Economic Commission for Europe
Inland Transport Committee
World Forum for Harmonization of Vehicle Regulations
Working Party on Pollution and Energy
Seventy-third session
Geneva, 7-10 June 2016
Item 9(b) of the provisional agenda
**Motorcycles and mopeds - Environmental
and Propulsion Performance Requirements
(EPPR) for L-category vehicles**

**Proposal for a new global technical regulation on the
measurement procedure for two- or three-wheeled motor
vehicles with regard to on-board diagnostics**

**Submitted by the Informal Working Group on Environmental and
Propulsion Performance Requirements (EPPR)***

Figure 1
Flowchart MI trigger activation criteria

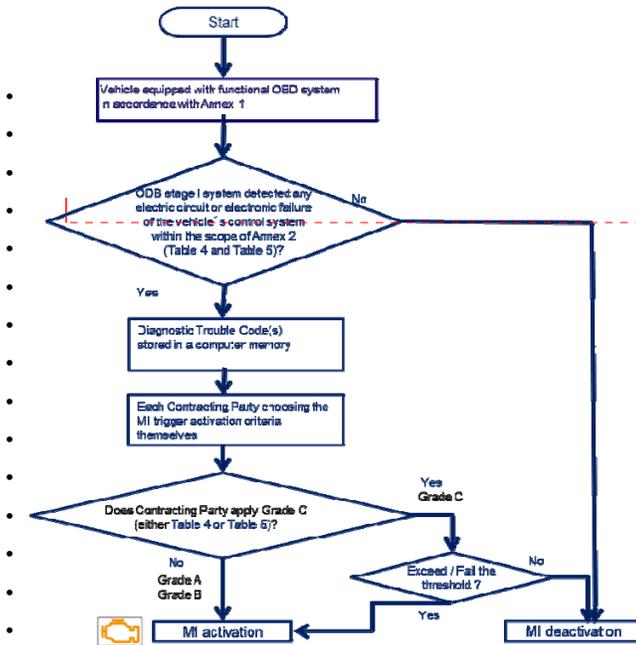
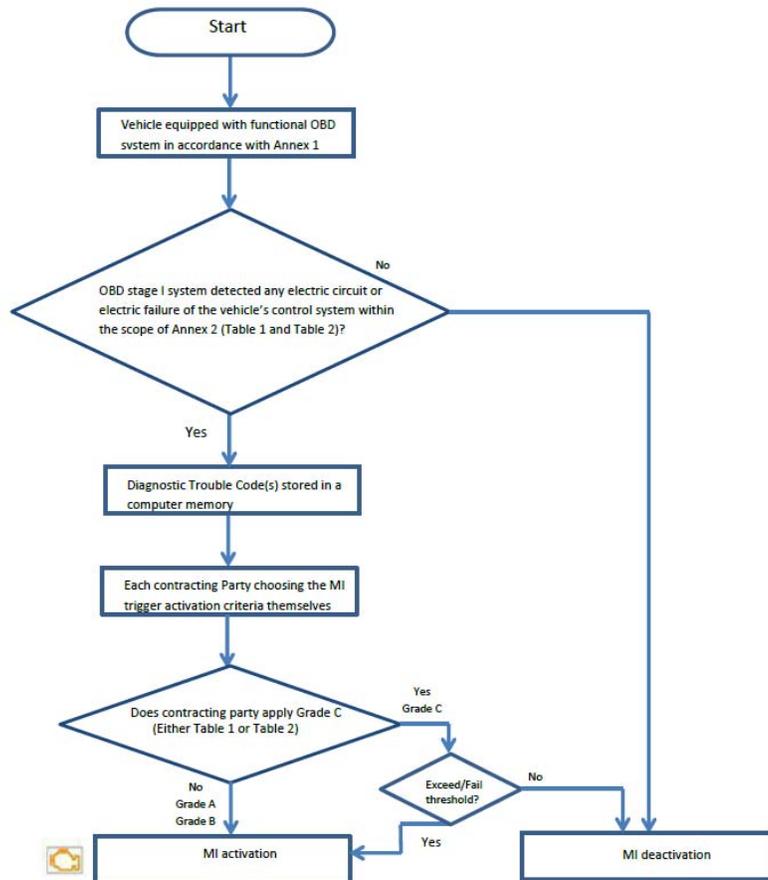
Comment [HM1]: Flowchart deleted. Corrected flowchart on next page.
